Architectural Review Board Staff Report

Project Type:	Amended Site Development Section Plan
Meeting Date:	November 14, 2019
From:	Mike Knight, Assistant City Planner <i>mk</i>
Location:	A 7.3 acre tract of land located northeast of the intersection of Wild Horse Creek Road and Old Chesterfield Road.
Description:	<u>Downtown Chesterfield Category C, Lot A (WILDHORSE) ASDSP:</u> An Amended Site Development Section Plan, Landscape Plan, Lighting Plan, Architectural Elevations and Architect's Statement of Design for a 7.3 acre tract of land located northeast of the intersection of Wild Horse Creek Road and Old Chesterfield Road.

Staff requests review and recommendation on this submittal for Downtown Chesterfield Category C, Lot A (WILDHORSE) Amended Site Development Section Plan.

Figure 2: Color Site Plan

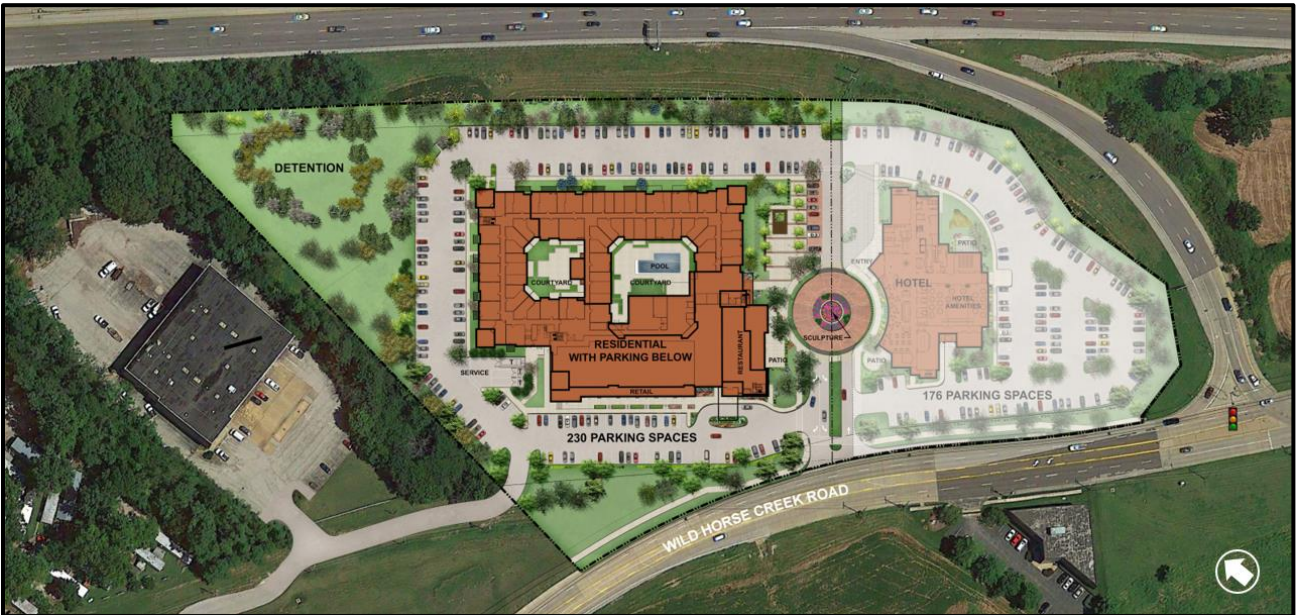
There are four primary changes on Lot A between the currently approved Site Development Section Plan and the submitted Amended Site Development Section Plan. These changes include updates to the parking garage, trash enclosure, round-about and 15 additional residential units. There are minimal changes to the site design and no changes to the building footprint.

Parking areas are distributed throughout the site around the building and through a parking garage under the building. The required parking for the site in accordance to the City’s Unified Development Code is 455 spaces. The current site plan has 230 surface parking spaces and 219 garage parking spaces totaling 449 spaces, which does not meet the minimum parking standards for the site. Although it does not meet the requirements for the site, the governing ordinance dictates that required parking is calculated globally throughout Category C (22 acres) and not calculated on an individual lot basis. When combining the required parking for both Lots A and B of Category C, the sites both meet the minimum parking requirements per the governing ordinance.

Figure 4: Trash Enclosure

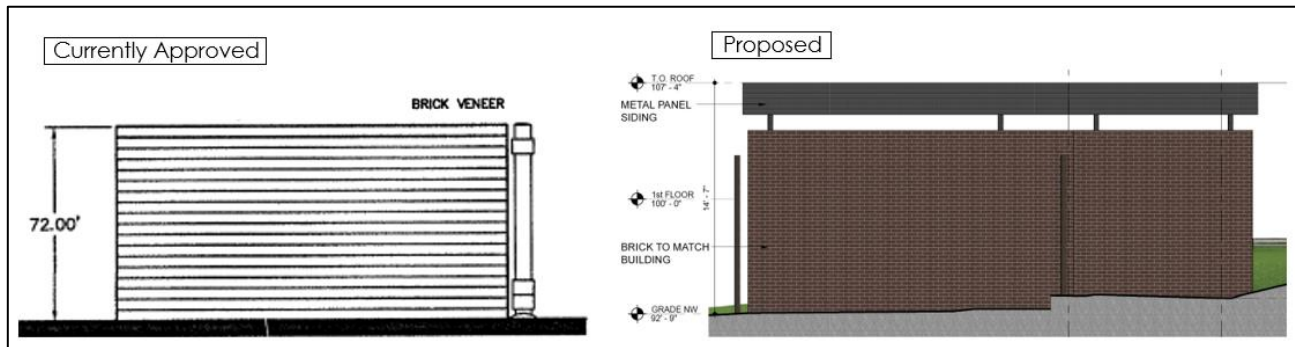
The footprint of the trash enclosure is largely the same. There are two main differences being proposed (Figure 4). The first is an additional metal panel on the top of the structure that is a similar feature to the metal panel located above the restaurant. The second is that the overall height of the enclosure is larger. The currently approved trash enclosure is 6' tall, while the new enclosure is roughly 14' tall including the metal feature depending on the grade change.

TRASH ENCLOSURE PLAN

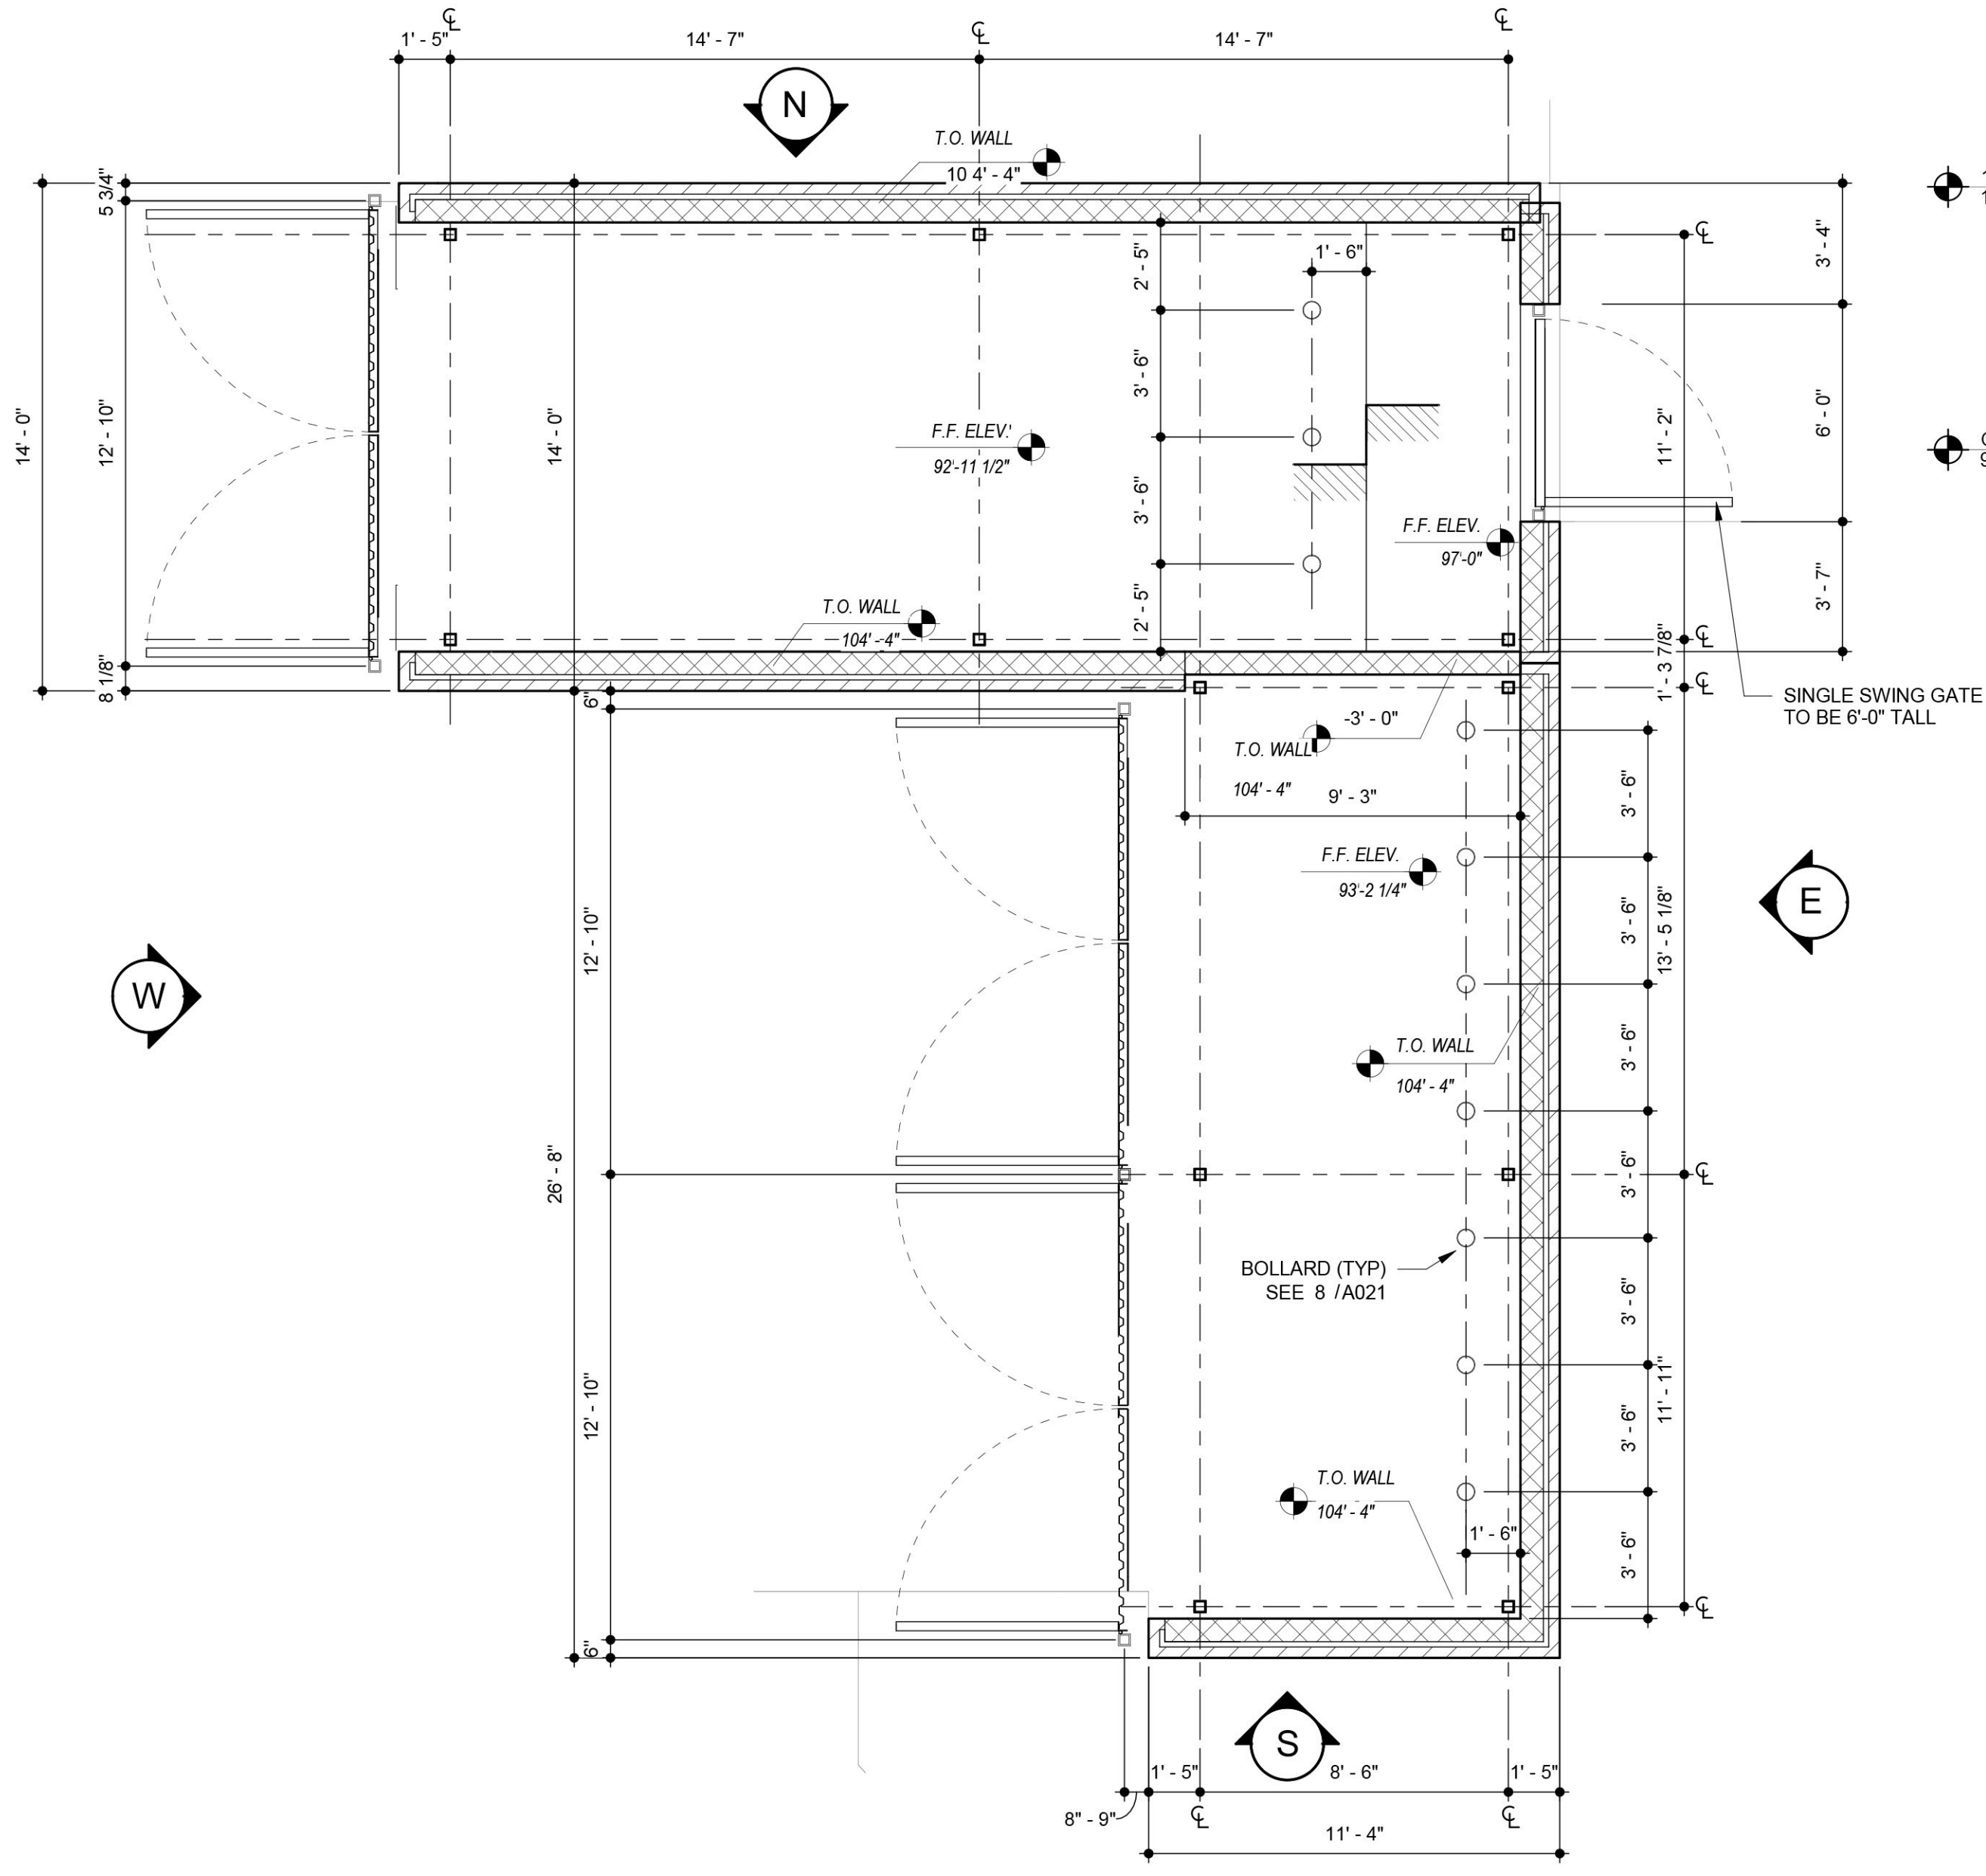
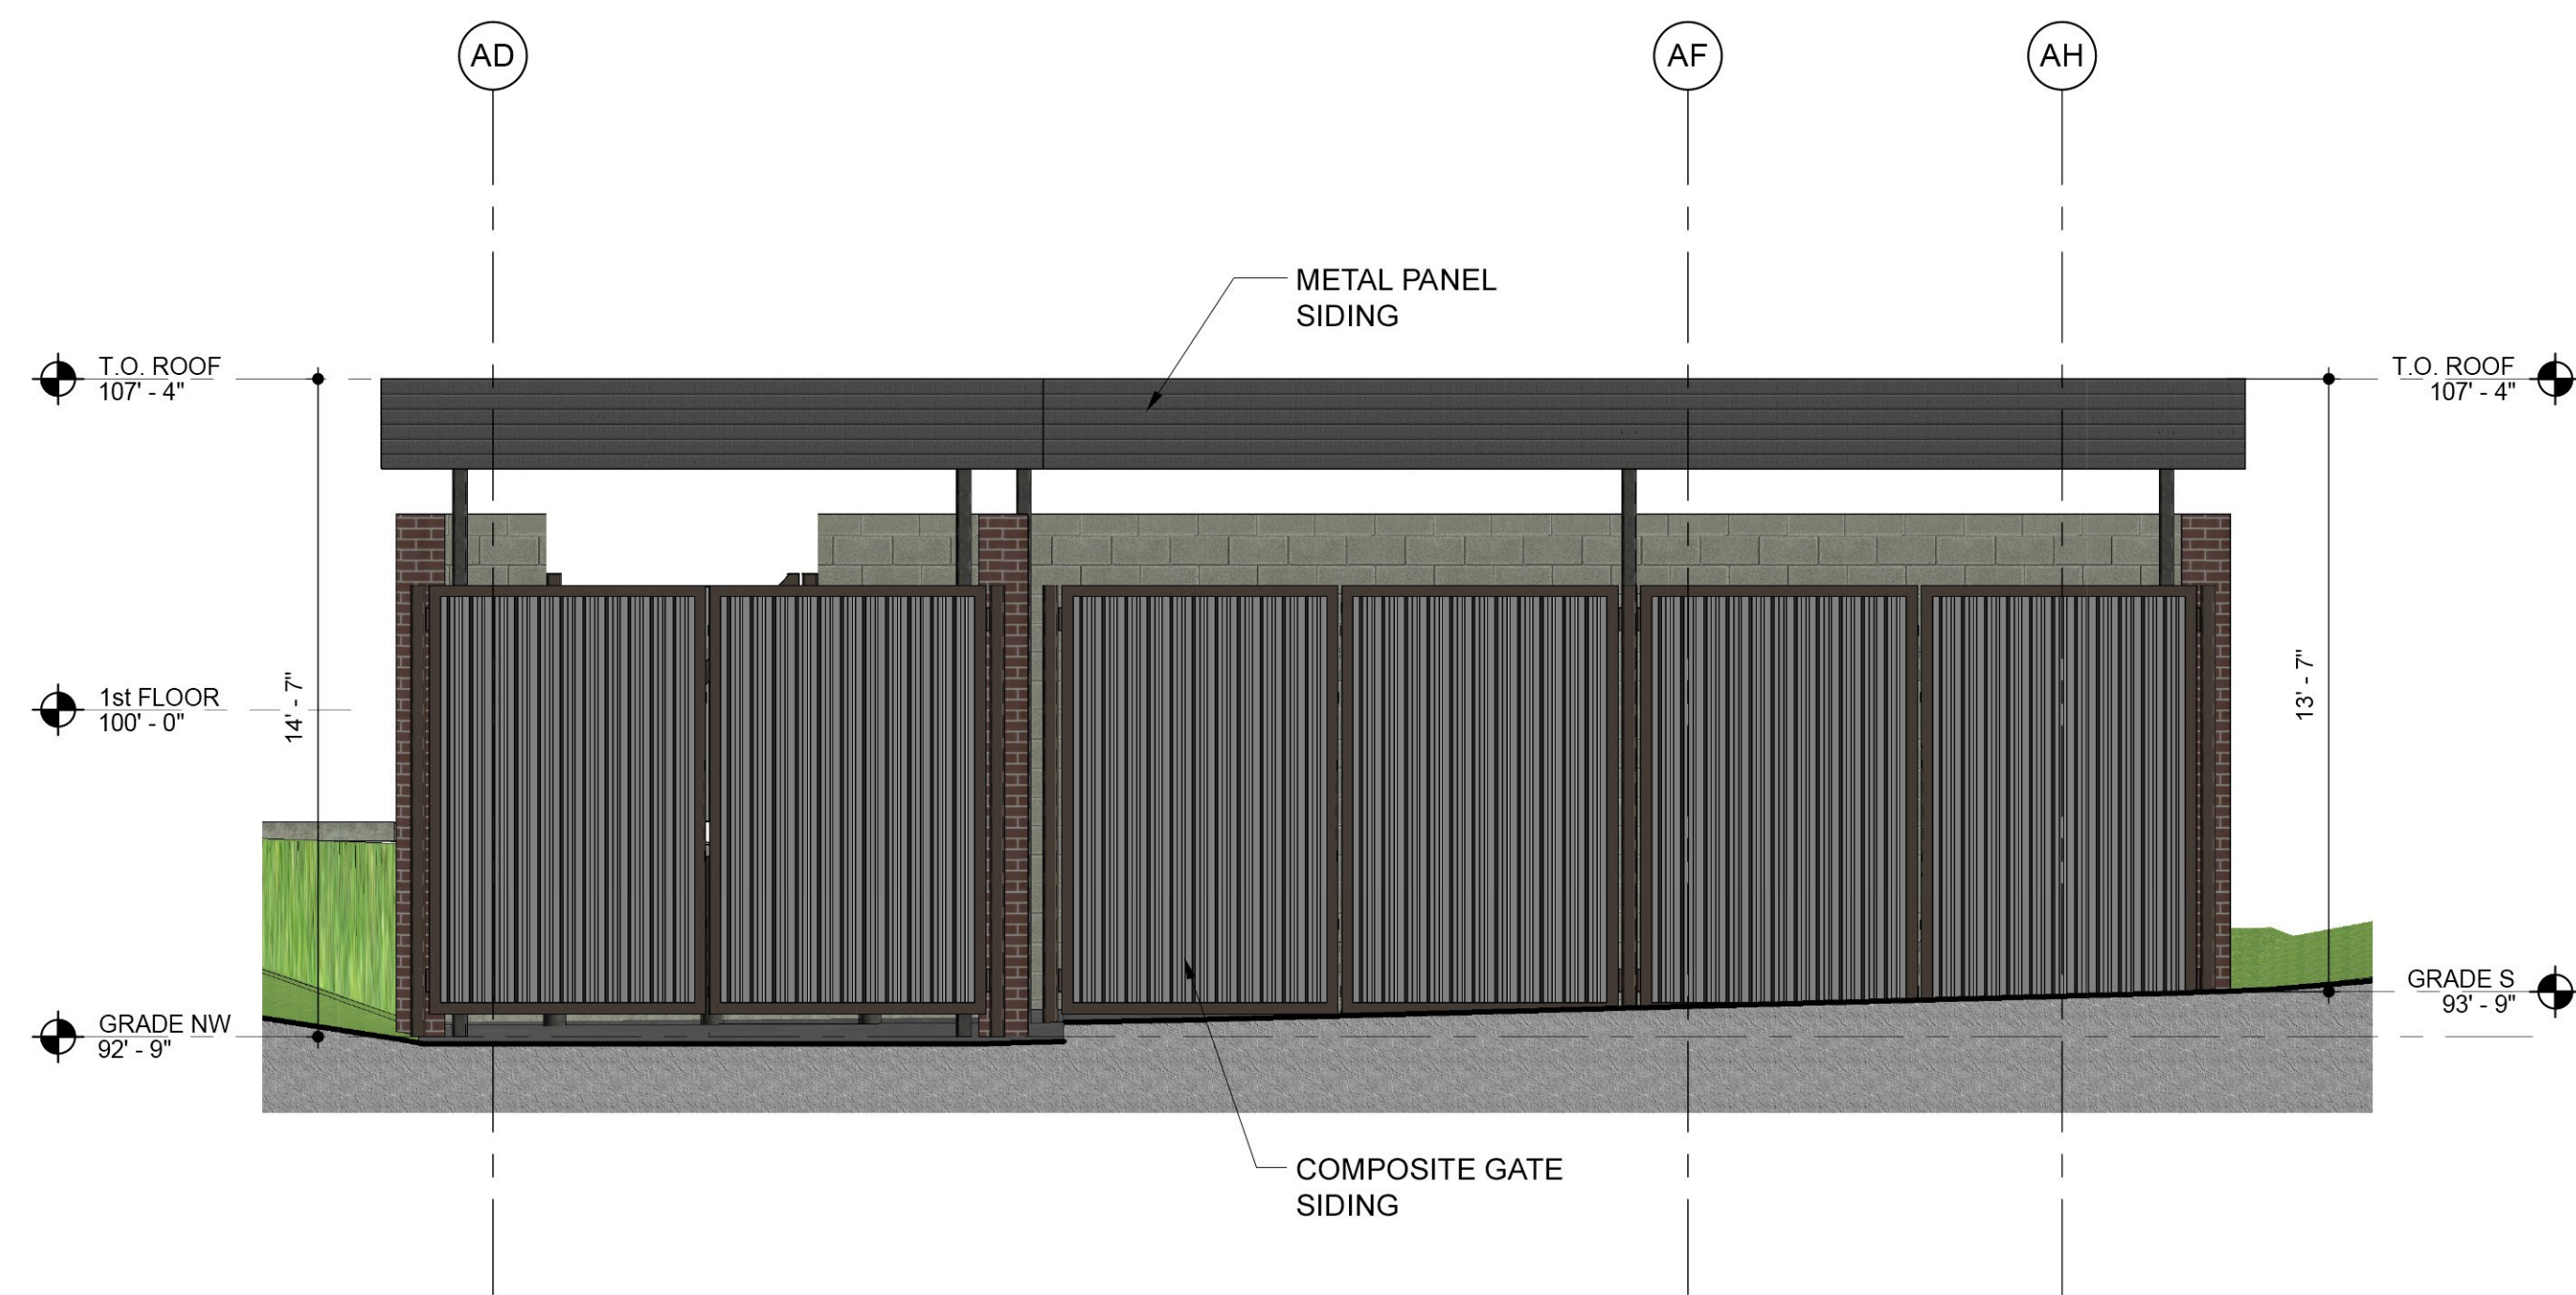
1. Openings in the north and west elevations of the garage have been revised to 1" insulated glass in aluminum storefront system, in lieu of, the previously approved fence material.
2. Metal louvers have been introduced on the north and west elevations of the garage. The intent is to paint the louvers to match the adjacent building material.
